**V2500-A1 PROPULSION SYSTEMS SERVICE BULLETIN**

This document transmits the Initial Issue of Service Bulletin EV2500-72-0372

**V2500-ENG-72-0372**

ENGINE – LP COMPRESSOR BLADES AND FILLERS – INTRODUCTION OF A REVISED WIDE CHORD FAN  
BLADE WITH DELETED ROOT STOP PIN AND REVISED FRONT AND REAR CHOCKING PADS

Detail of blade root rework  
Fig 1

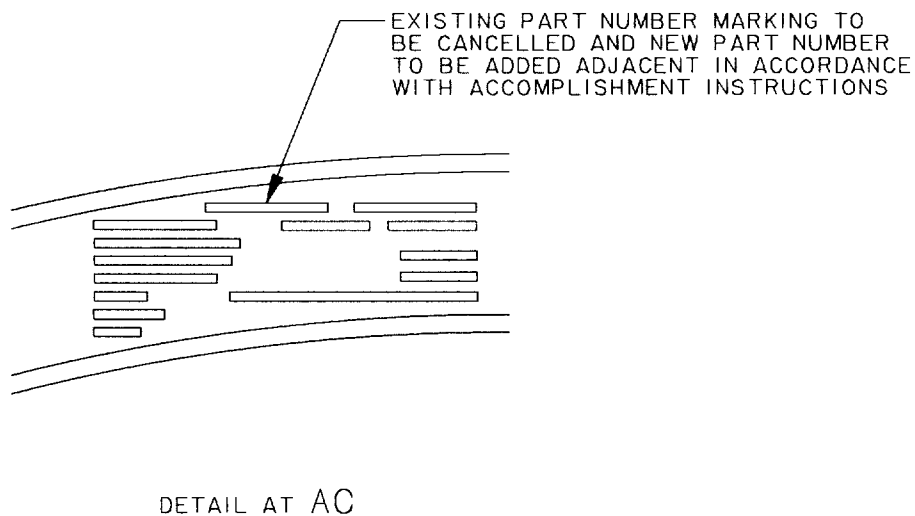
PROCEDURE	RELATED DATA										
(1) Remove front and rear chocking pads from blade	Refer to (EM), 72-31-11-300-013, (Repair VRS1028)										
(2) Remove pin from blade root	Refer to Fig 1. Use radial arm drill.

Root pin to be removed underflush on the fan blade root to a depth of 0,20mm to 0,70mm. No existing material to be removed from the blade root. Remainder of pin to remain in blade root	Tooling		3R19555	Machining fixture	3R19556	Centralizing pin	3R19557	End mill	3R19558	Setting gauge
Tooling											
3R19555	Machining fixture										
3R19556	Centralizing pin										
3R19557	End mill										
3R19558	Setting gauge										
(3) Clean blade root	Refer to (EM) TASK 72-31-11-100-000. Use chemical cleaning equipment

MACHINE WHERE MARKED ✓  
MACHINE SURFACE FINISH TO BE 250 MICROINCHES (6,4 MICROMETRES)  
REMOVE ALL BURRS

Refer to Fig 1. Refer to Standard Practices Manual (SPM) TASK 70-21-01-220-501. Visually examine the blade root. Reject if blade root material has been removed or pin has been totally removed

Detail of blade root rework  
Fig 2

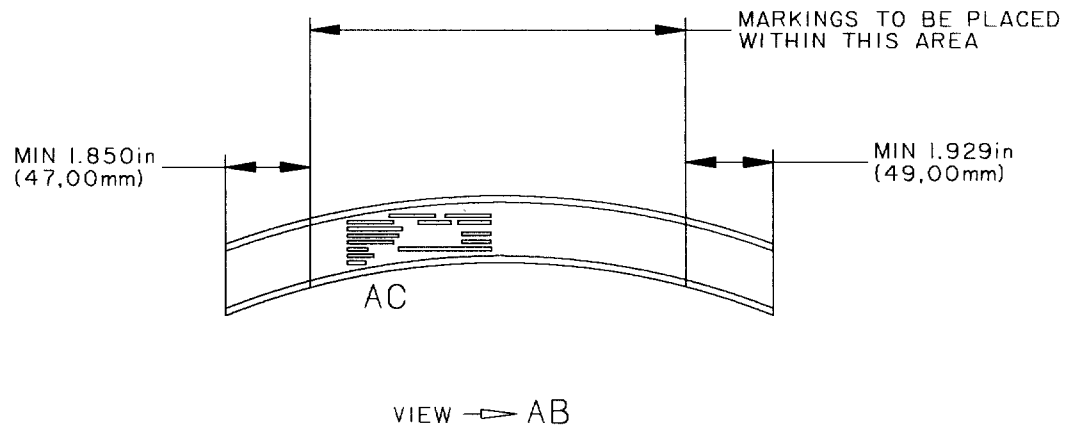
- (5) Re-identify by cancelling the existing blade assembly part number and adjacent to it, mark new assembly part number followed by the letters 'ASSY'

Refer to Fig 2. Refer to SPM TASK 70-09-00-400-501. Use vibro-peening equipment
